M E M O R A N D U M

SUBJECT: NEC® Second Draft Correlating Committee and Ballot to Forward FINAL Ballot Results (A2025)

Second Correlating Revision No. 129-NFPA 70-2025 [Global Input]

Figure 90.3 Code Arrangement.

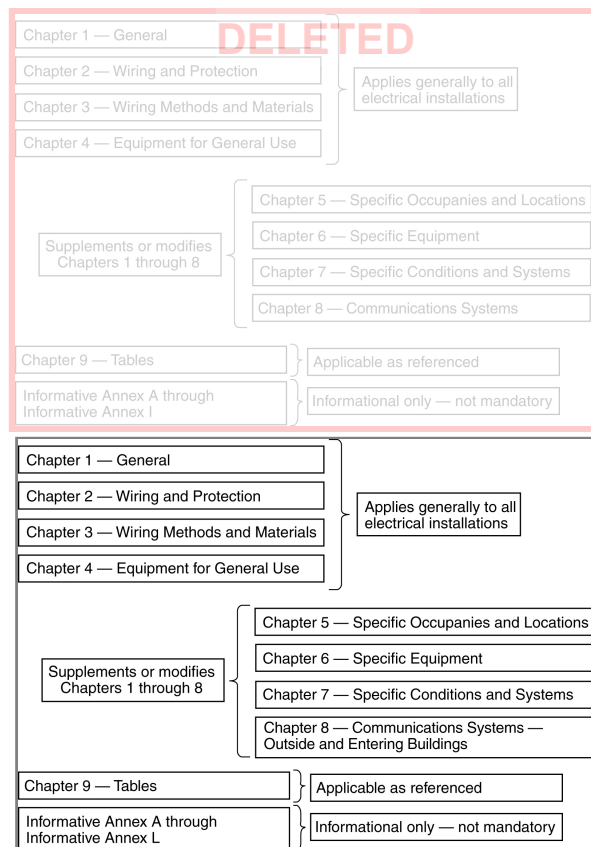
Committee Statement: This revision is for correlation with the change of the title of Chapter 8. Additionally, the titles of the chapters in the table of contents are to be revised to align with Figure 90.3.

Committee Statement: Changes made in Figure 90.3 have revised the titles from "Special" to "Specific"

Figure Informational Note 708.54 Critical Operations Power System Selective Coordination.

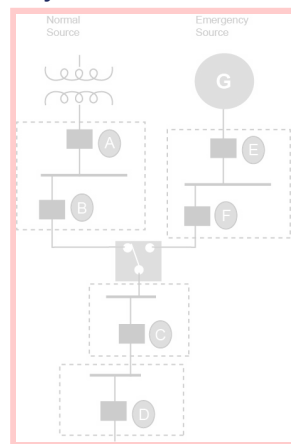
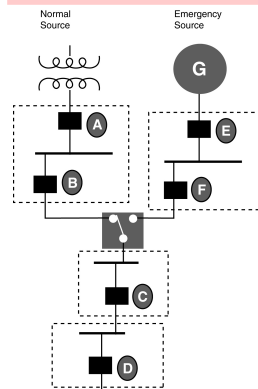
~~OCPD F selectively coordinates with OCPD E.~~

~~OCPD B is not required to selectively coordinate with OCPD A because OCPD B is not a critical operations power system OCPD.~~

DELETED

OCPD D selectively coordinates with OCPDs C, F, E, B, and A.
OCPD C selectively coordinates with OCPDs F, E, B, and A.
OCPD F selectively coordinates with OCPD E.
OCPD B is not required to selectively coordinate with OCPD A,
because OCPD B is not a critical operations power system OCPD.

The language has been revised to align with the defined terminology concerning overcurrent protection and overcurrent protective devices (OCPDs).
